## OICA comments on WP.29-181-10

## FIA proposal on OTP Protection profile of an Automotive Gateway\*

### ➤ Issue of increased traffic on communication busses (CAN, LIN, etc.)

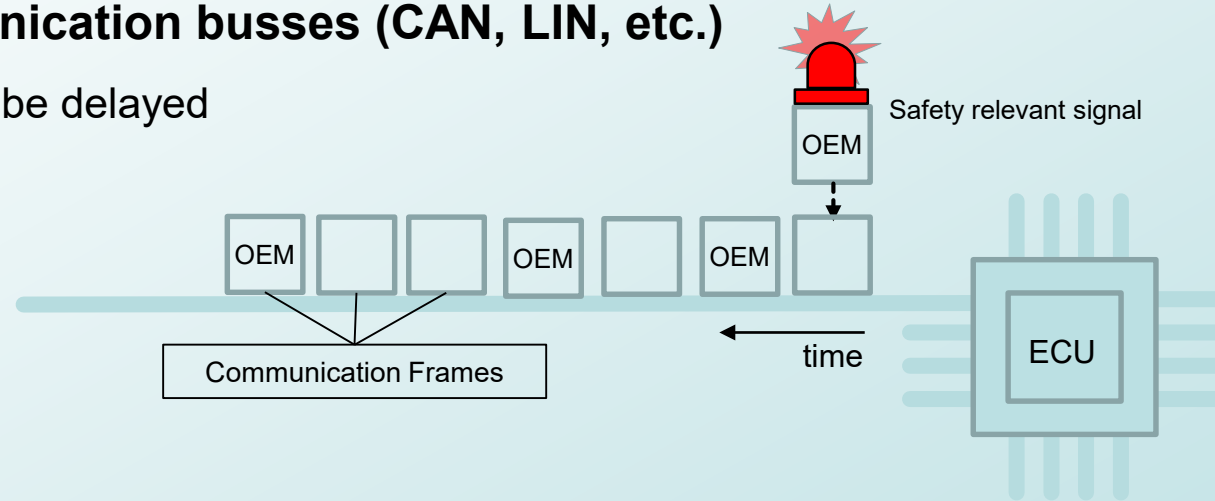
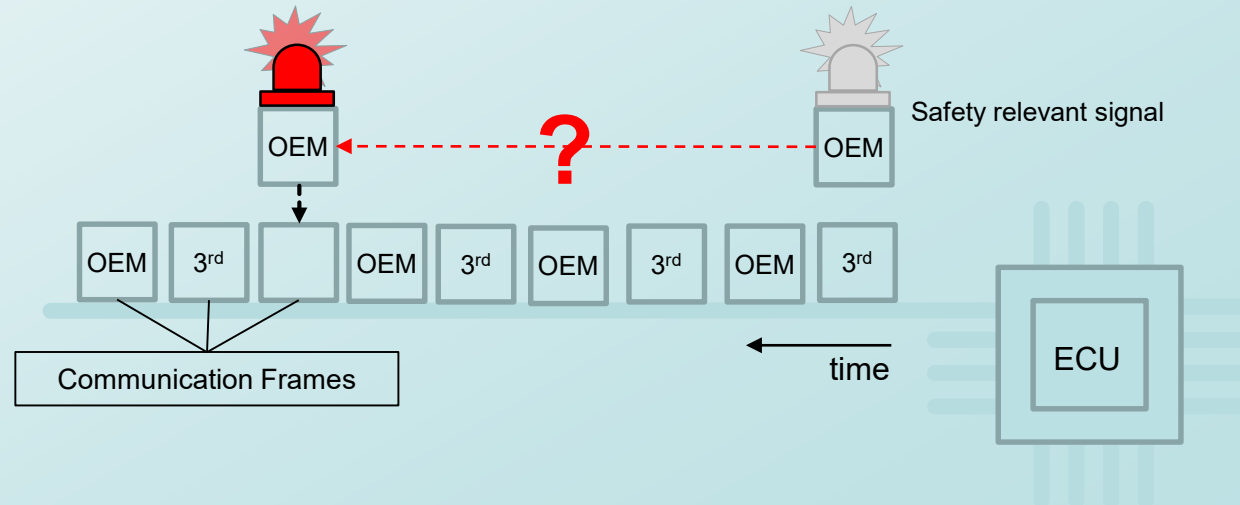
- Delivery of safety relevant signals may be delayed

## Automotive Gateway device (1/4)

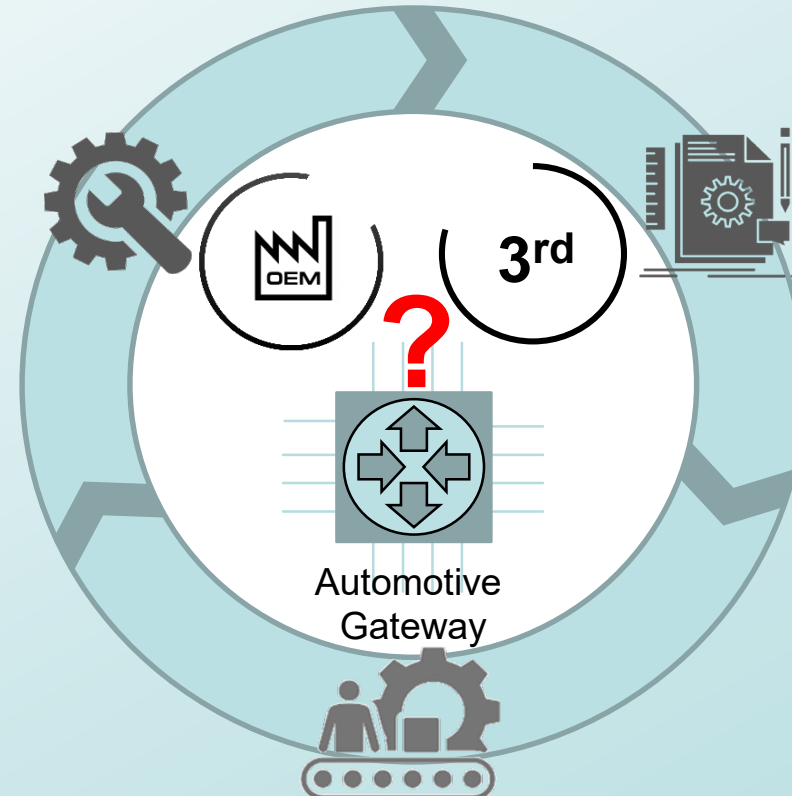
- Who is developing / manufacturing / certifying / maintaining this component?

## Automotive Gateway device (2/4)

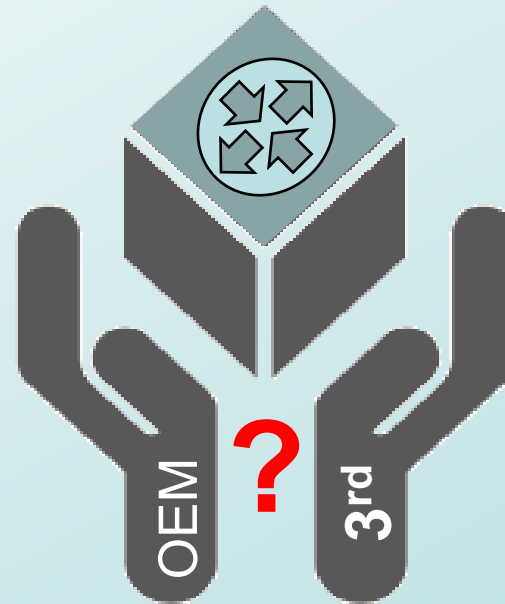
- Who is overall responsible for the component incl. its safety and security?

## Automotive Gateway device (3/4)

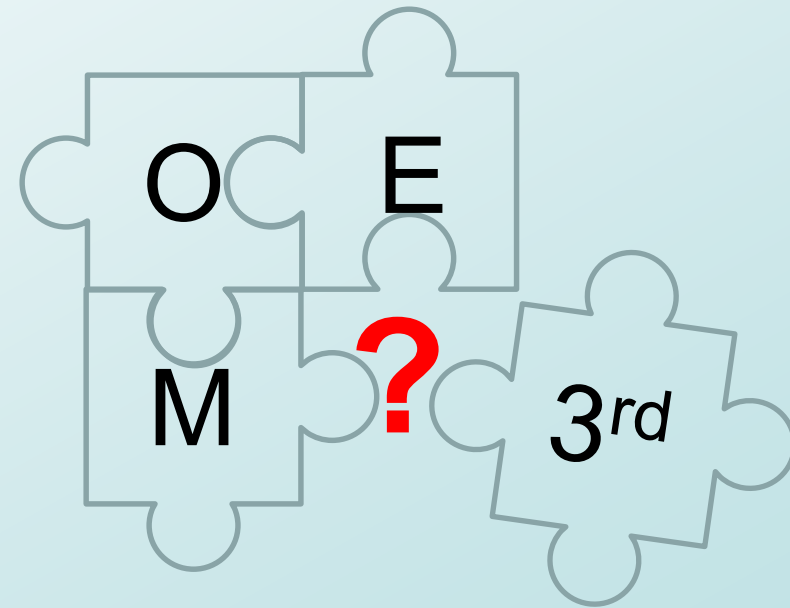
- How to ensure proper implementation within the different vehicle architectures?

## Automotive Gateway device (4/4)

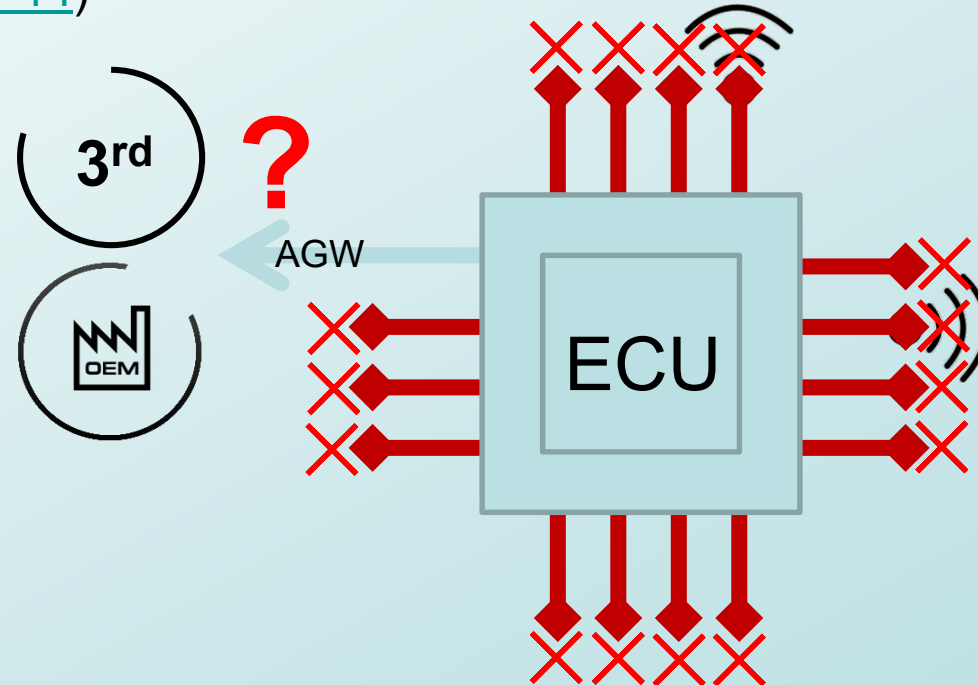
- Is it the intention that the Automotive Gateway is the one and only communication channel between the E/E architecture and outside world?
- If yes, how is time critical communication ensured via this gateway (e.g. for ADAS)
- See also Annex (FIA Presentation [TFCS 11-14](#))
